**Subject: Response to Comments: Phase II Report  
Millersville Landfill and Resource Recovery Facility  
Severn, Maryland**

This letter has been prepared by Geosyntec Consultants (Geosyntec) in response to your January 15, 2025, letter regarding your review of the Phase II Geology and Hydrologic Report for the proposed vertical expansion of Cell 9 at Millersville Landfill and Resource Recovery Facility located at 389 Burns Crossing Rd in Severn, Maryland. Please find attached a detailed response to each comment made in your January 15, 2025, letter as well as two copies of the updated text, tables, figures, and added appendices of the Phase II report for your review.

## Response to Comments

### Phase II Report: Site Geologic Study

<b>RESPONSE TO COMMENTS</b>	
MILLERSVILLE LANDFILL AND RESOURCE RECOVERY FACILITY SEVERN, ANNE ARUNDEL COUNTY, MARYLAND	
	FIGURE 1
PROJECT NO: ME1418A	FEBRUARY 2025

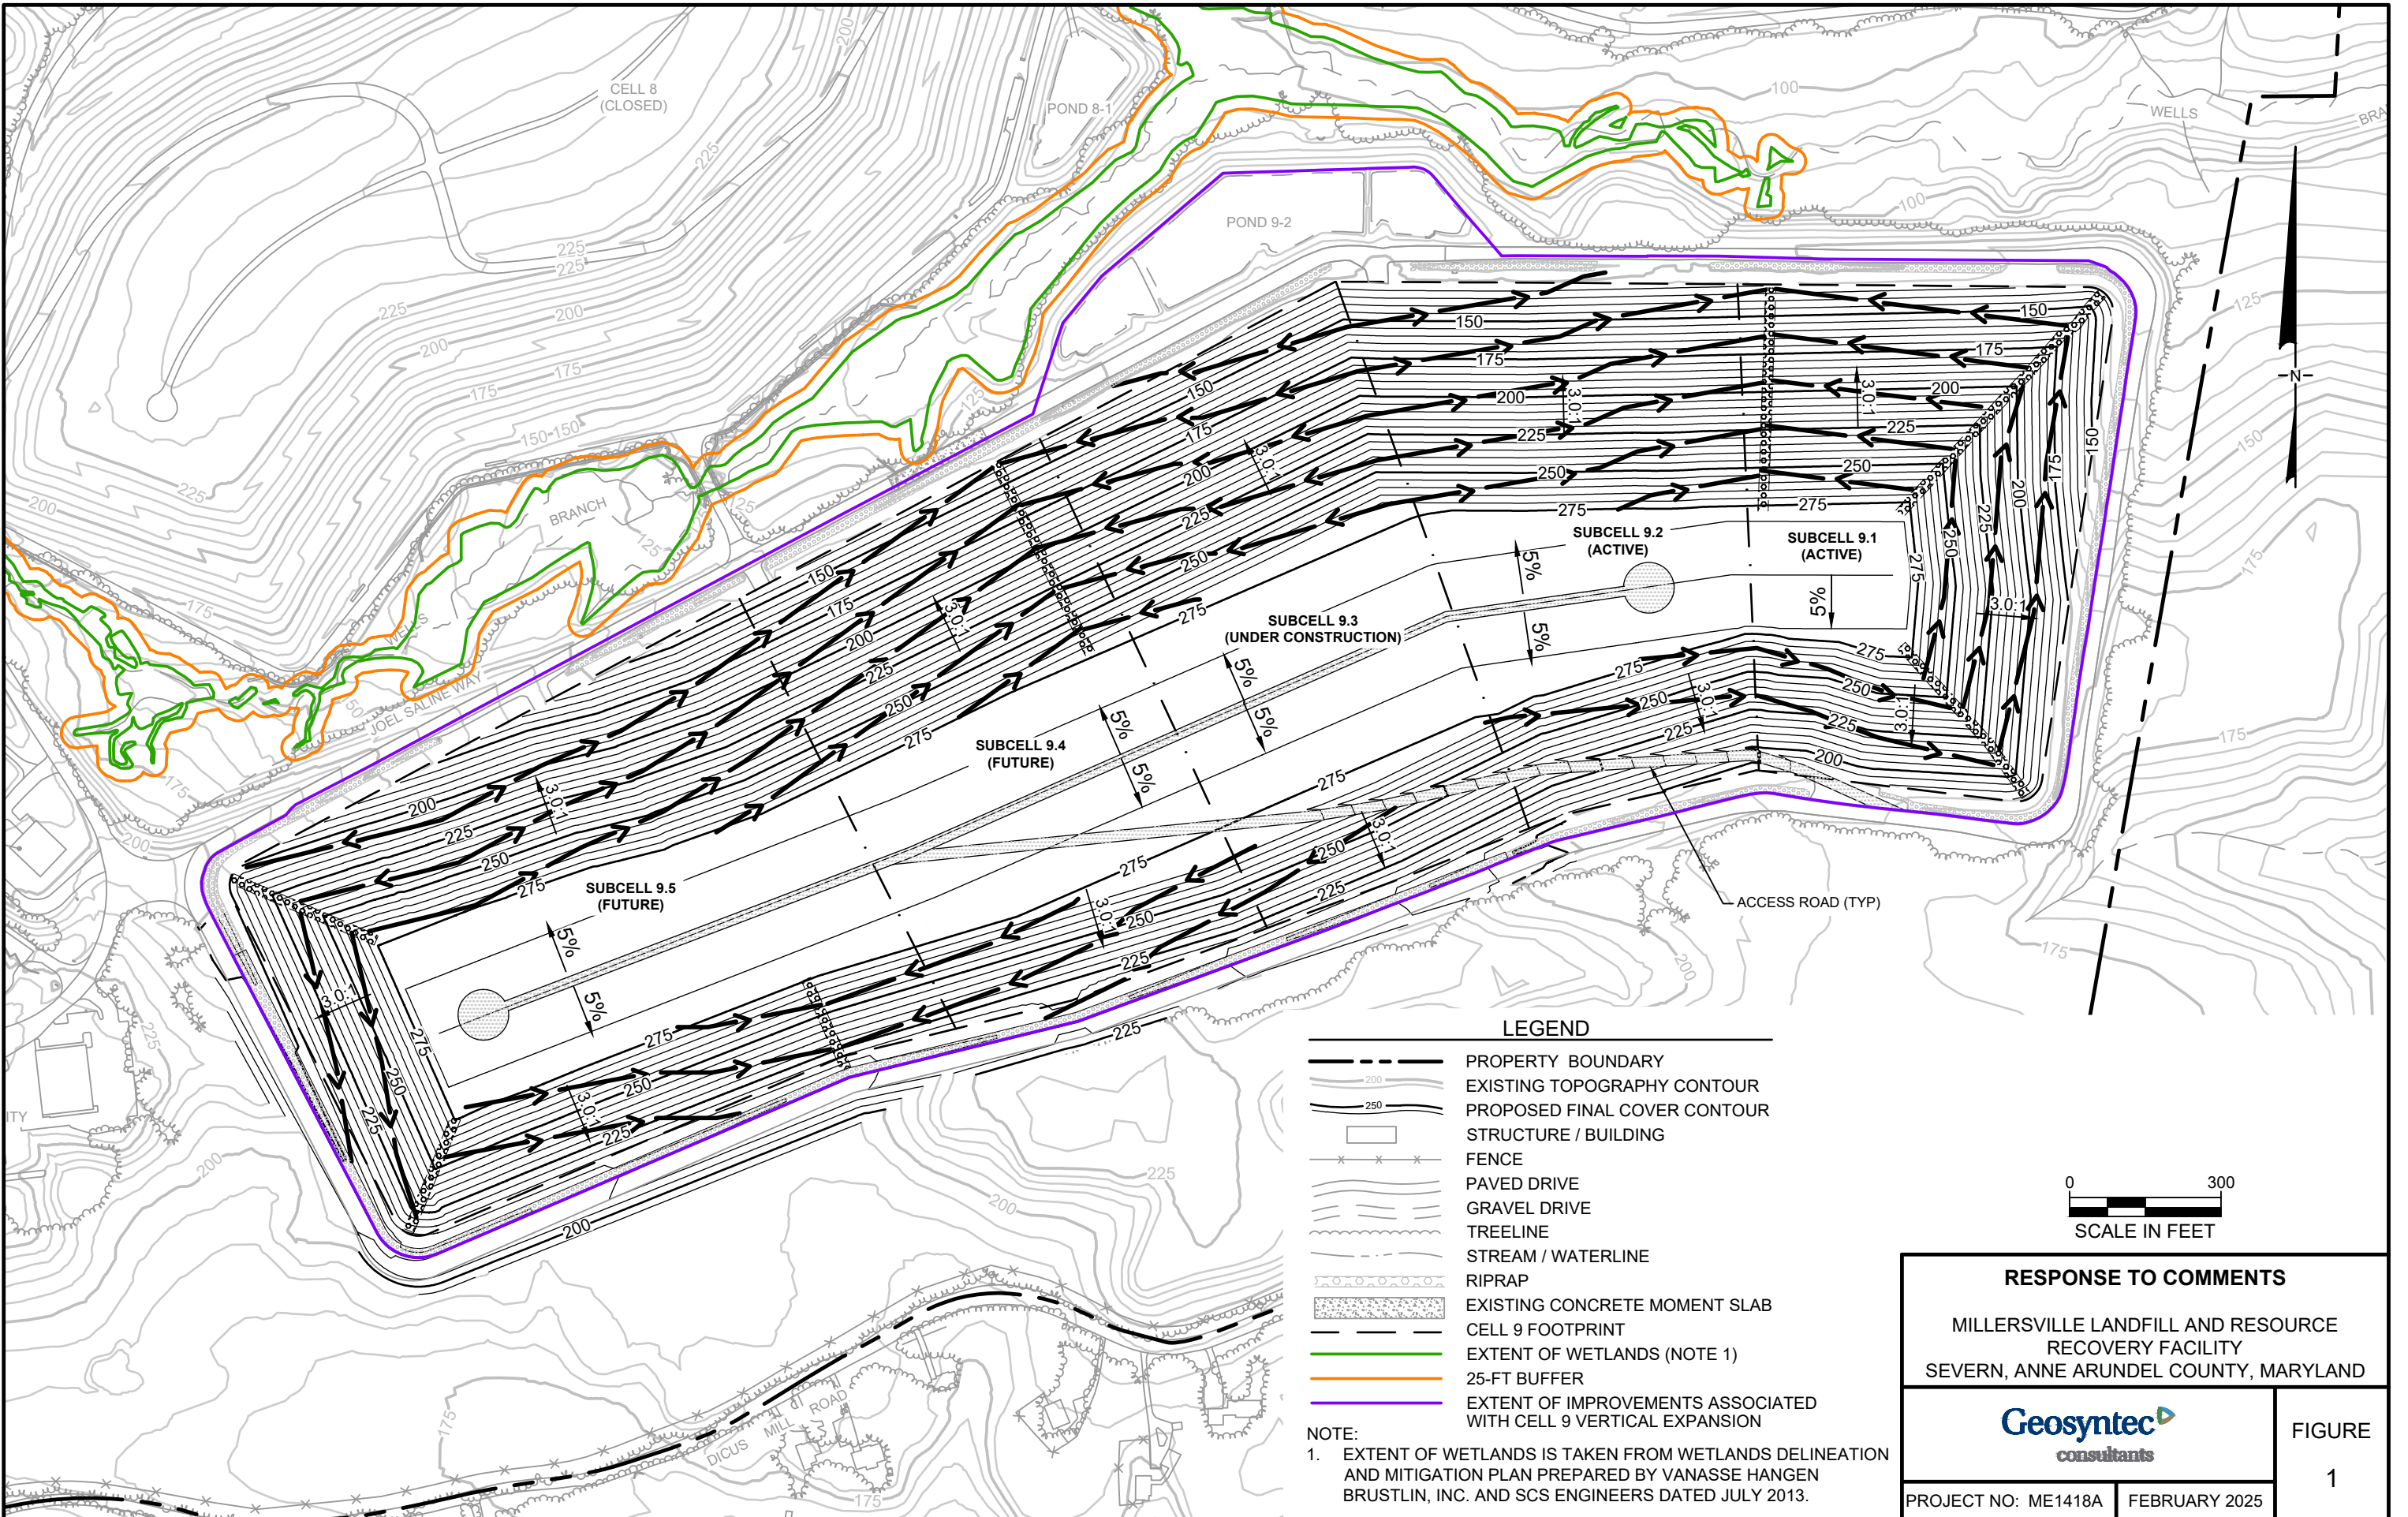
13. Please contact Amanda Sigillito of the Department's Nontidal Wetlands & Waterways Program at (410) 537-3766, if the project will impact nontidal wetlands, the nontidal wetland buffer or waterways, including the 100-foot nontidal buffer. The property owner will need to submit a Joint Federal/State Application for the alteration of any Floodplain, Waterway, Tidal or Nontidal Wetlands. Prior to applying for the application it is recommended to schedule a pre-application meeting with this provided link:

*Based on MDE guidance<sup>1</sup>: "a nontidal wetlands permit is needed for disturbance within a 25-foot buffer of a non-tidal wetland, which can be expanded to 100 feet for steep slopes, highly erodible soils, or nontidal wetlands of special state concern. All nontidal wetland sites with 100-foot buffers have been designated by regulation and are mapped on the nontidal wetlands guidance maps." Based on the Maryland Wetlands (Special State Concern) GIS maps<sup>2</sup>, there are no nontidal wetlands of special state concern adjacent to Cell 9, and as such, a 25-foot buffer is appropriate to consider for Wells Branch (also known as the unnamed Severn Run tributary). The attached Figure 1 shows the existing wetlands and 25-ft buffer, as delineated by Vanasse Hangen Brustlin, Inc., on May 12, 2012, and November 8 and 9, 2012, and as confirmed by the US Army Corps of Engineers on April 23, 2013 (as provided in Appendix A of the Phase II report). No work is proposed as part of the Cell 9 expansion within this 25-foot buffer, as no work is proposed outside the previous Cell 9 limit of disturbance.*
